***KODAK X-Omatic* MULTILOADER 300**

MODIFICATION No. 52

To upgrade the operating software to version 4.00 from version 3.xx

figure 1-2

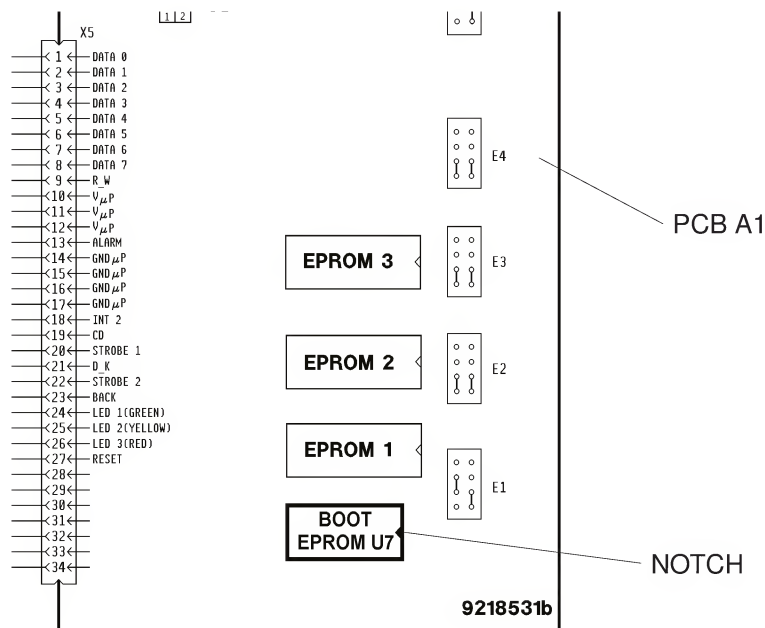
1. Switch off the XML 300.
2. Take off the following panels:
 - TOP COVER
 - REAR PANEL
 - RIGHT-HAND SIDE PANEL
3. Replace the existing BOOT EPROM on PCB A1 U7 with the new one from the MODIFICATION KIT. Insert the new BOOT EPROM with the NOTCH to the right.

figure 1-3

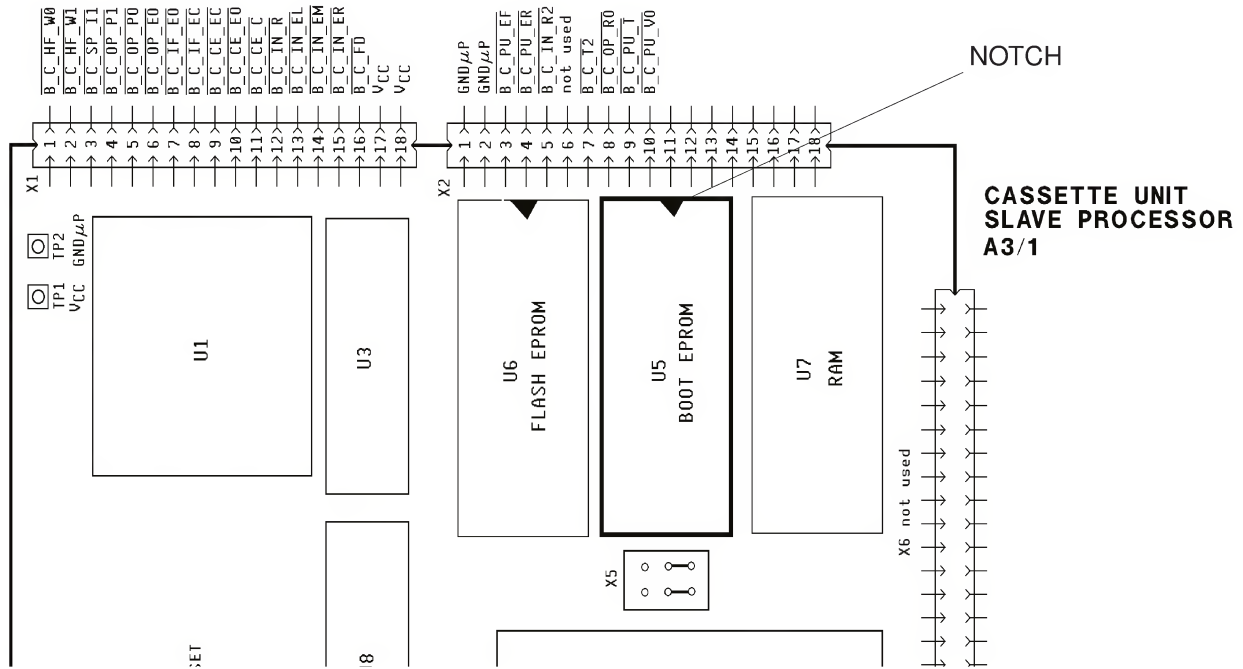
- Replace the existing BOOT EPROM on PCB A3/1 U5 with the new one from the MODIFICATION KIT. Insert the new BOOT EPROM with the NOTCH to the right.

figure 1-4

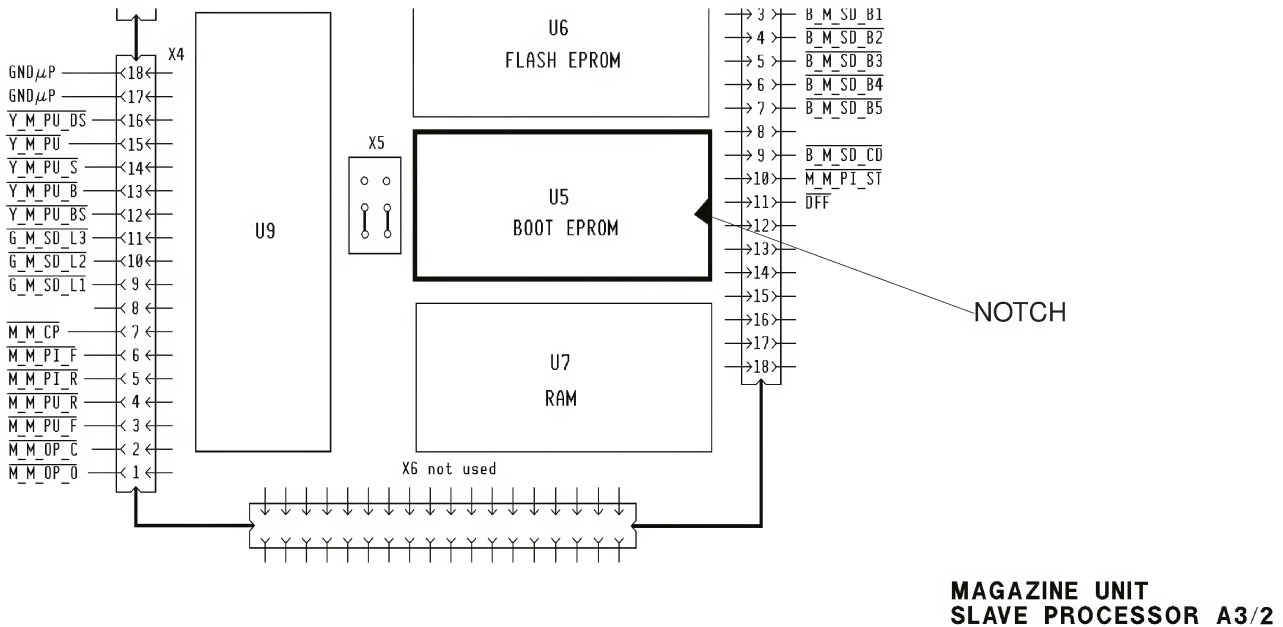
- Replace the existing BOOT EPROM on PCB A3/2 U5 with the new one from the MODIFICATION KIT. Insert the new BOOT EPROM with the NOTCH to the right.
